REVISIONS					
ZONE	REV	ECN	DESCRIPTION	DATE	DRAWN APP'D
	A		ORIGINAL RELEASE	08-AUG-02	GDL JIB
	B	02R00820	REDRAWN ON PROE, MODIFY NOTES MOVE LEGEND TO SECOND SHEET ADD MOTOR DETAILS AND NOTE # 6	16-JAN-03	CHF MS
B6	C	03R00349	REMOVE REDUNDANT HATS UPDATED A FEW DESCRIPTIONS - SHEET 2	19-MAR-03	CHF MS
D4 B4 MISC B6	D	03R00400	CHANGE SYMBOL FOR SUPPRESSOR - RC1 CHANGE SYMBOL FOR MMSa UPDATE TERMINAL BLOCKS TO PHYSICAL COUNT SHOW JUMPER FROM TB # 7 TO # 8	04-APR-03	CHF MS
C5 C6 D2	E	70805	UPDATE 230 AND 460 V MOTOR LEAD CONNECTIONS - ADDED THE NOTE ON REVISION LEVEL REFERENCED ON DRAWINGS	19-AUG-03	CHF MS
	F	71119	ADD 3MTR, 3M, 4MTR, 4M, FOL, 3ATT IRPS, 2RPS AND PORO OPTION	22-DEC-03	WFD DGC
C6	G	71437	RELOCATED THE DISPLACED TEXT T1, T2, T3, & T3, T2, & T1 IN ZONE C6	30-MAR-04	BBV CHF
A5 C7	H	71750	UPDATED REF DRYER ADDED POWER FOR ELECTRONIC OVERLOAD ADDED 30L SPECIFICATION IN "SUPPLIED AND WIRED BY STARTER MFG." TABLE	06-JUL-04	VIJAY CHF

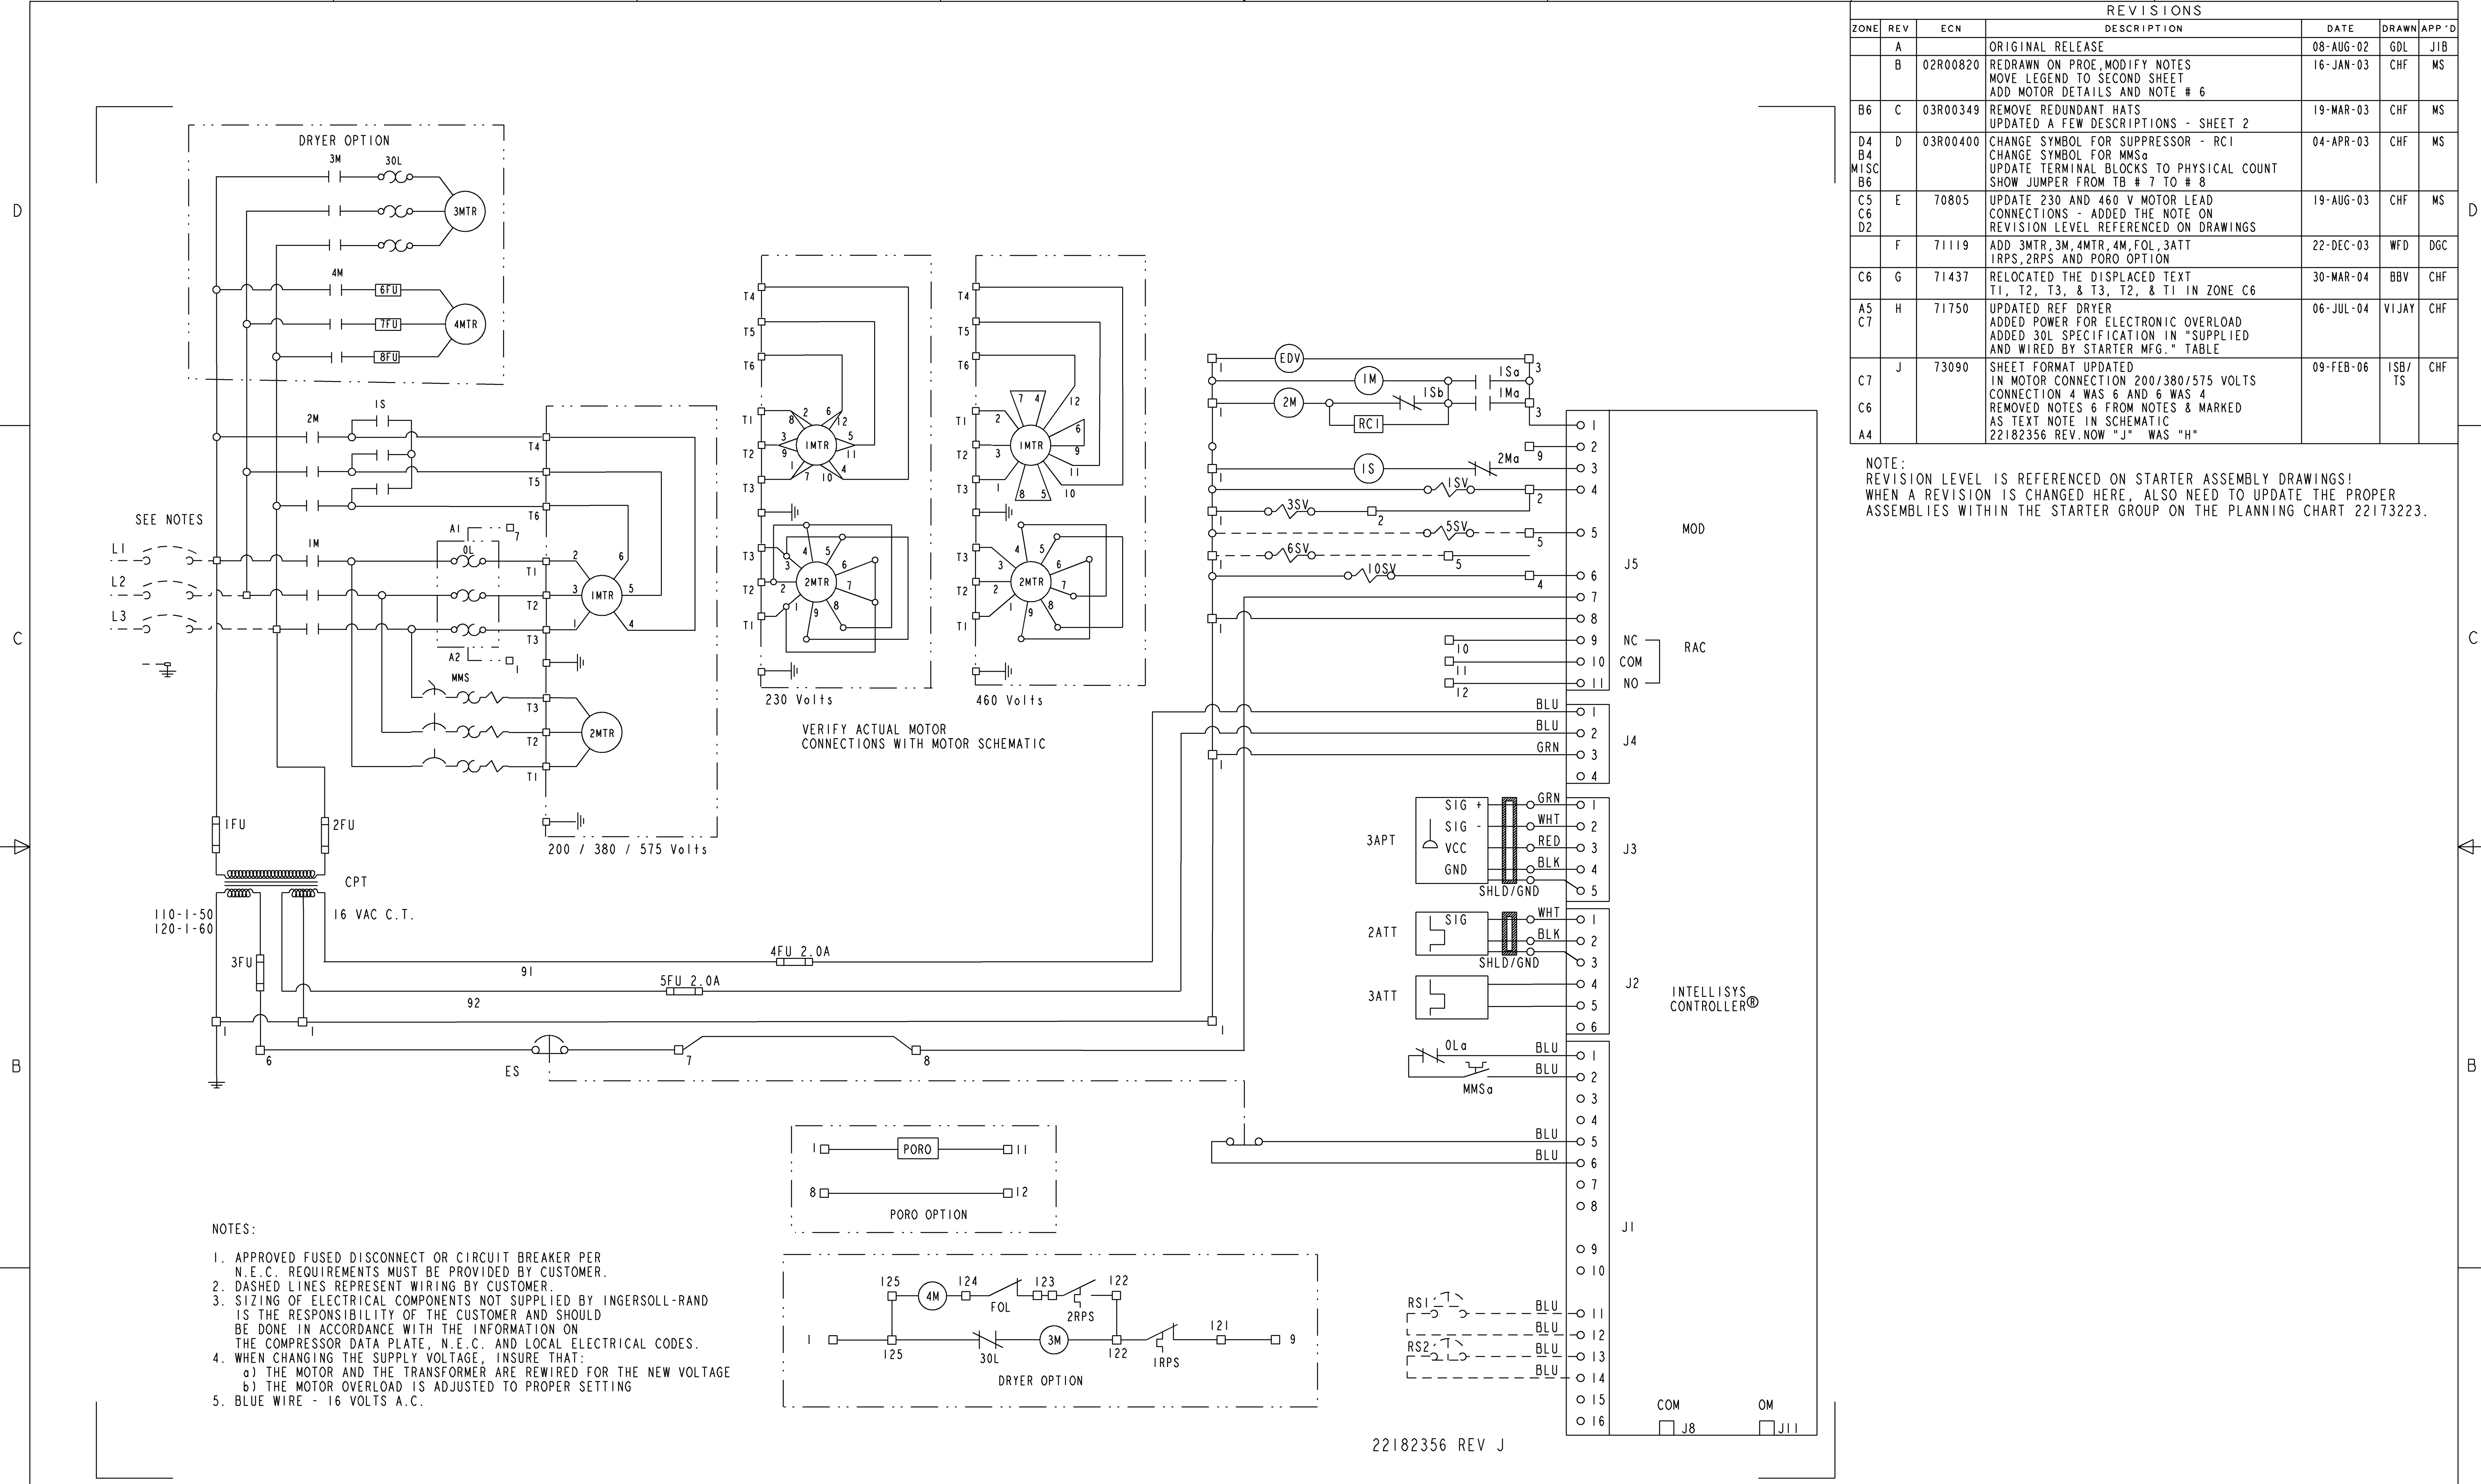
C7 C6 A4	J	73090	SHEET FORMAT UPDATED IN MOTOR CONNECTION 200/380/575 VOLTS CONNECTION 4 WAS 6 AND 6 WAS 4 REMOVED NOTES 6 FROM NOTES & MARKED AS TEXT NOTE IN SCHEMATIC 22182356 REV. NOW "J" WAS "H"	09-FEB-06	ISB/TS CHF
